SUB-APPENDIX D6-L

Peer Review Memorandum #2

Re: Memorandum #2: Project No. 18111331 Ridge Landfill Expansion EA Phase 2000
Leachate collection for the proposed expansion of the old landfill, EA REF No. 16019

Figure A: Showing the proposed top contours and lower (17m), median (23 m) and upper (28 m) bound predicted leachate mound (directly from Attachment 6)

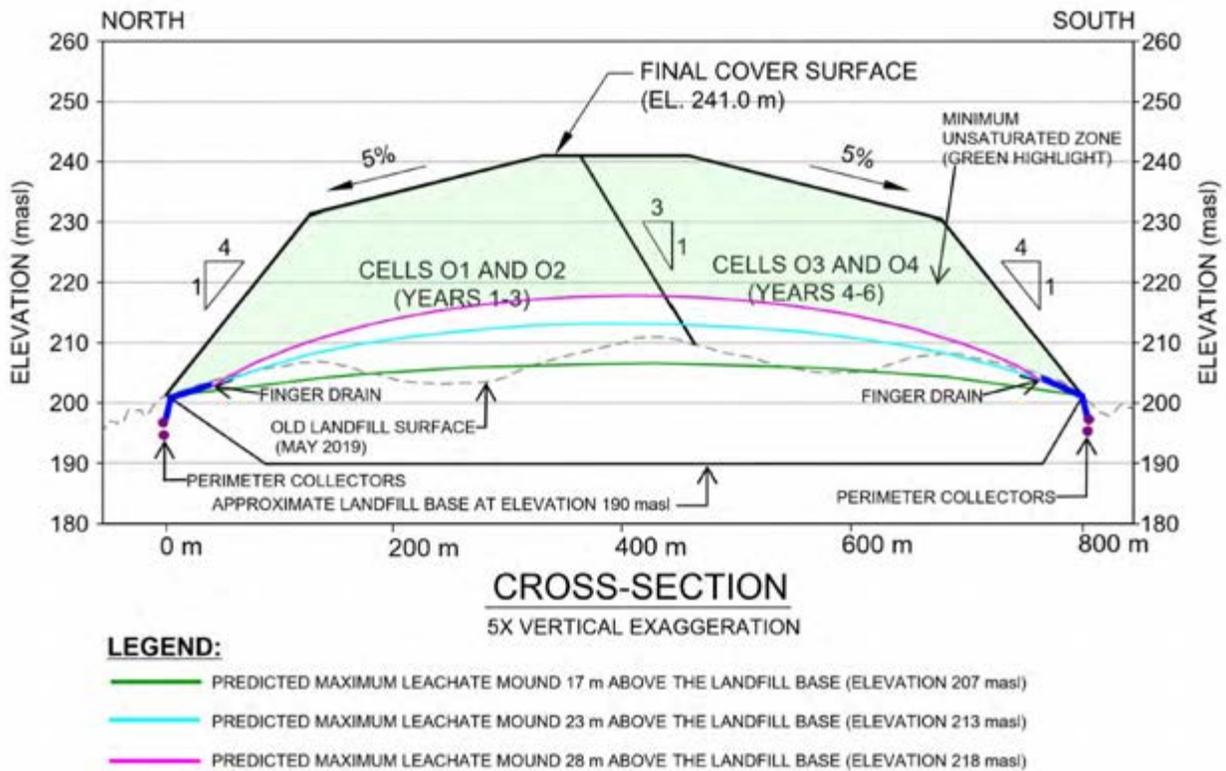
If waste was homogeneous and isotropic, no leachate seeps would be expected until the mound reached the level that it intersected the surface of the landfill. Based on the calculations performed by Dillon/Golder this would seem unlikely (see Figure A below which is Figure 2 in Attachment 6). However, since the possibility cannot be excluded, I consider the request for monitoring wells by MECP to be quite reasonable and indeed Golder has indicated a willingness

to address this issue by adding two additional leachate monitoring wells as described in their March 20, 2020 Technical Memorandum (Attachment 4).

The fact that waste is highly non-homogeneous and anisotropic implies that there is potential for surface seeps even when leachate mound is well away from the surface contours of the landfill (as in Figure A above). This is because there can be preferential lateral flow (often on a low permeability layer such as daily cover that had not been adequately broken up) from the leachate mound to the surface of the landfill causing a seep. This can also occur above the leachate mound due to the perching of leachate and a low permeability layer can result in preferential migration laterally to the surface of the landfill to form a leachate seep. The finger drains that form part of the proposed Old Landfill expansion design is intended to provide a preferential path for this leachate and to prevent it from reaching the surface. Although discrete finger drains are an effective design approach to manage seeps, they cannot be expected to capture all possible such pathways. The surface seeps, while likely to be significantly reduced compared to what would be expected in the absence of finger drains, can still be expected to occur at some time in the future. In recognition of this, and in response to MECP comments, Golder has proposed a three-stage

trigger and corrective action plan (Attachment 7, §17.3) that, in my opinion, is quite appropriate and realistic and should address anything from minor local seeps through to more significant and frequent seeps over a larger area. Provided these actions are taken in a timely manner after the detection of a seep, and the perimeter drain is kept clean and effective, I expect that these measures should be sufficient to prevent contamination of surface water or shallow groundwater (deep groundwater is addressed below).
